VENETIA STATION SUBDIVISION

APPLICATION NUMBER 5 DATE November 7, 2013

REQUEST Subdivision

SITE PLAN

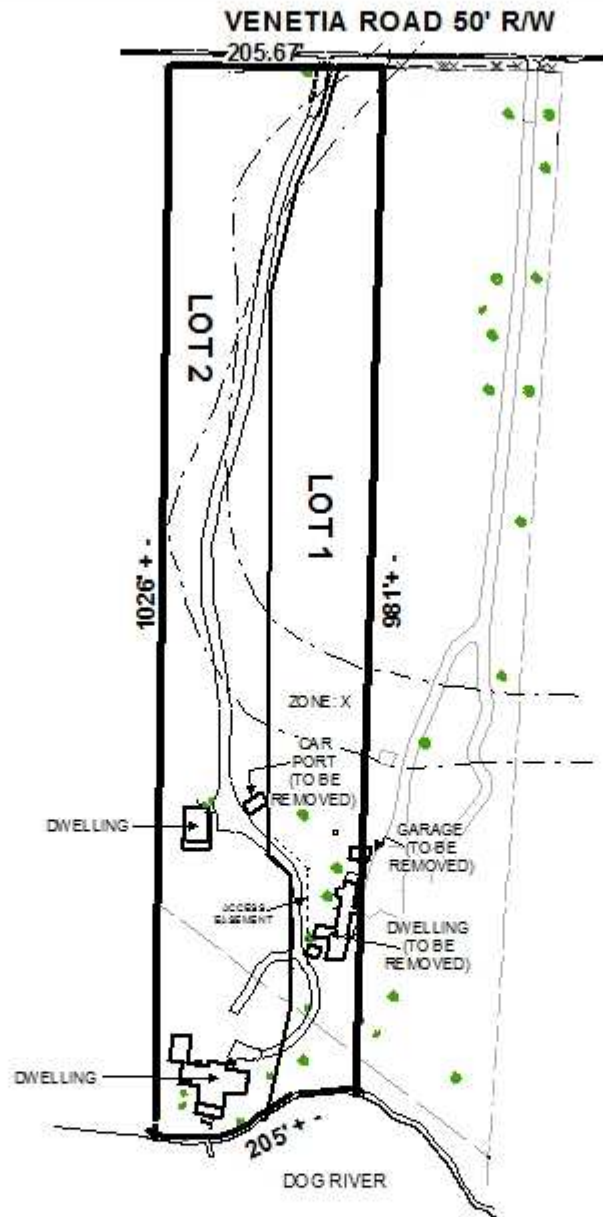
While this is a subdivision application there are Zoning Ordinance related issues that should be addressed. The plat displays property lines going through existing structures on the each site. It appears the existing carport on Lot 2 is encroaching onto Lot 1. The plat also depicts an existing garage located on Lot 1 encroaching onto the adjacent property. The proposed Lot 2 illustrates two dwelling units on a single building site which is not permitted in a Single Family Residential District. Furthermore, there is no nonconforming documentation on file regarding the existing multiple dwelling units. A rezoning application will be required for R-2 zoning or a variance to the Board of Zoning Adjustment. The plat also illustrates one driveway that appears to provide access to the three existing dwelling units located on the site. Because the site is located within the city, the Zoning Ordinance requires structures to be a minimum of 8' from the property line and a Planned Unit Development (PUD) is required to allow multiple structures on a single site, and to allow shared access. If approved, it should be noted the site would create several zoning violations.

The site plan also depicts a single family dwelling unit adjacent to the proposed Lot 1; however, it should be noted there is no longer a structure on the adjacent property. The property adjacent to Lot 1 should be included in the subdivision since shared access currently exists, and the encroachment of the garage onto the adjacent property. Revisions to the site plan to reflect all current structures shall be required.

The 25-foot minimum building setback line, required in Section V.D.9., is noted on the plat but not illustrated. Revisions should be made to depict the 25' minimum building setback line on the preliminary plat, and should be retained on the Final Plat, if approved.

This application was heldover from the October 3rd meeting to allow the applicant to submit a revised plat. The revised plat illustrates all current and existing structures with notations to indicate what structures will be removed. The existing dwelling unit on the proposed Lot 1 is shown to be removed. The existing carport located on the proposed Lot 2 as well as the existing garage on the proposed Lot 1 are shown to be removed, which addresses the concern of property lines bisecting or going through structures. Due to the note on the plat stating the drive and access easement will only be used for the proposed Lot 2, and the removal of both the existing garage and dwelling unit so that the structures will no longer encroach onto the adjacent property to the East, all applications for a PUD is no longer required.

Furthermore, it should be noted the 25' minimum building setback line is not illustrated on the plat.

- 1) revise site plan to depict 25' minimum building setback line;*
- 2) provide nonconforming documentation to show that the multiple single family dwelling units existed prior to 1967, and that the guesthouse has been in continuous use or submit for a rezoning application or use variance application; or removal of the cooking facilities from the guesthouse prior to the signing of the Final Plat;*
